**CITY OF AUSTIN – TRAVIS COUNTY – SINGLE SUBDIVISION OFFICE
SUBDIVISION APPLICATION – MASTER COMMENT REPORT**

CASE NUMBER: C8J-2019-0186.1A
REVISION #: 00 UPDATE: U0
CASE MANAGER: Sarah Sumner PHONE #: 512-854-7687

PROJECT NAME: Premier Logistics Park
LOCATION: 2900-1/2 FERGUSON LN

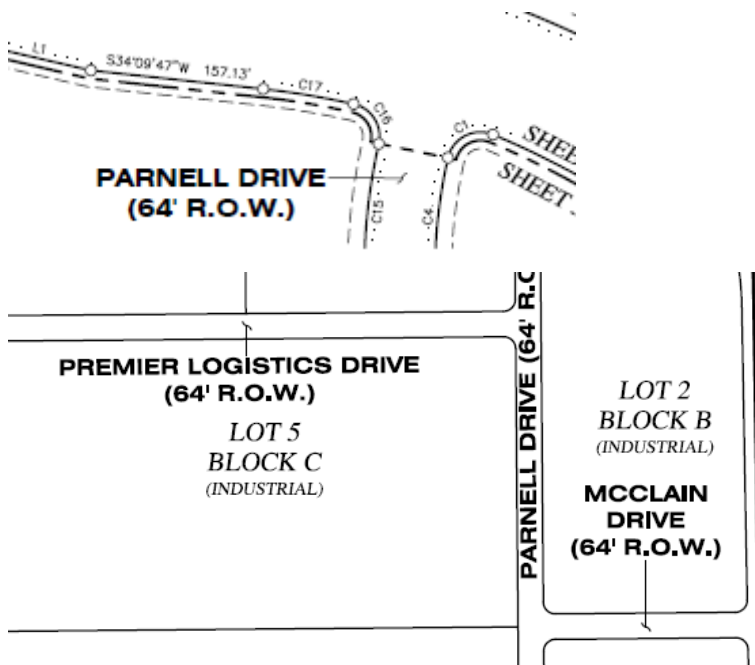
AD2: RUNDBERG is a continuation of TUSCANY WAY and must continue the same name. It also does is an active street name and does not have a street type is therefore a duplicate. Please change and resubmit for review. If not, please clarify.

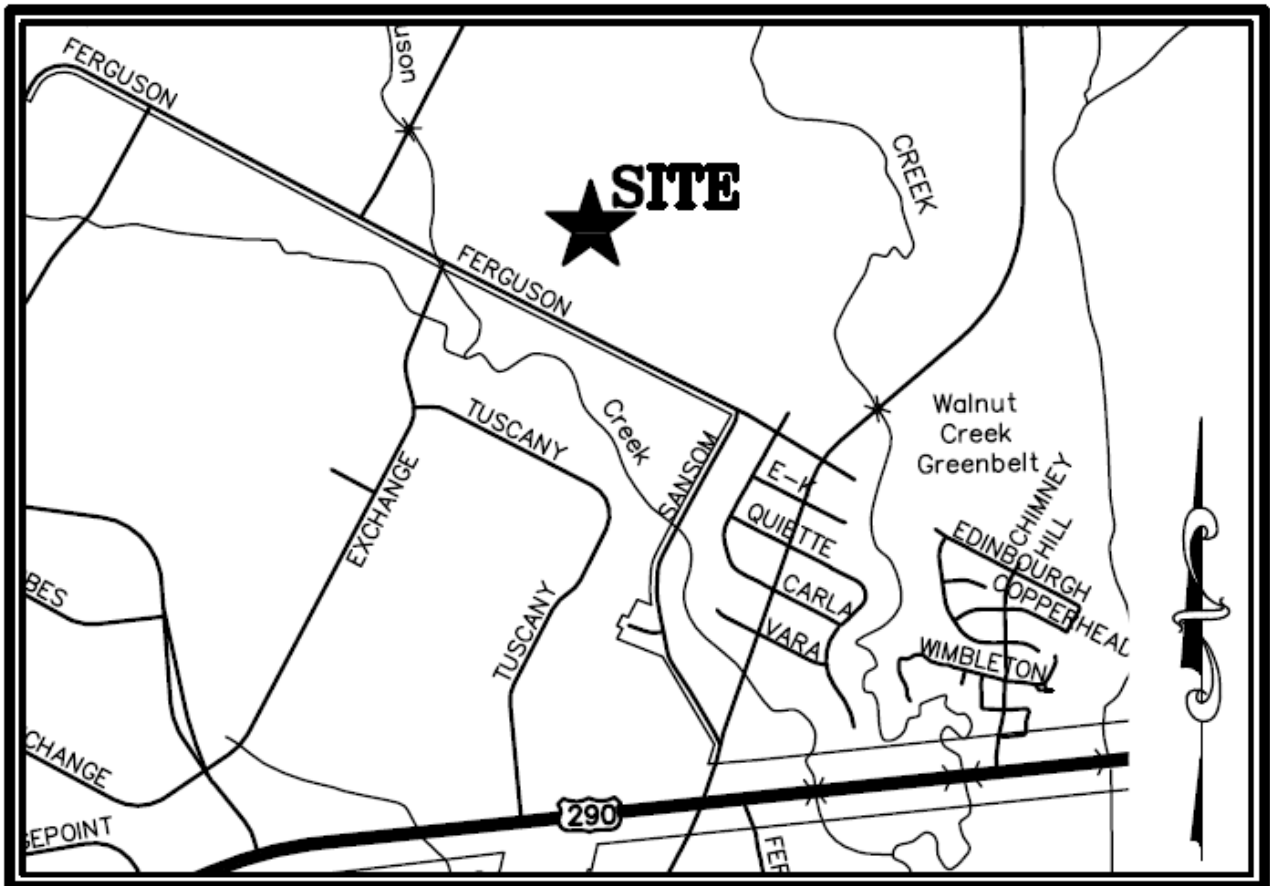
AD3: Please add the label, PARNELL DR, MCCLAIN DR within the R.O.W, and not as a call out.

AD4: Please include street types in all street names in the vicinity map

AD5: Please remove the punctuation marks for all street names and types
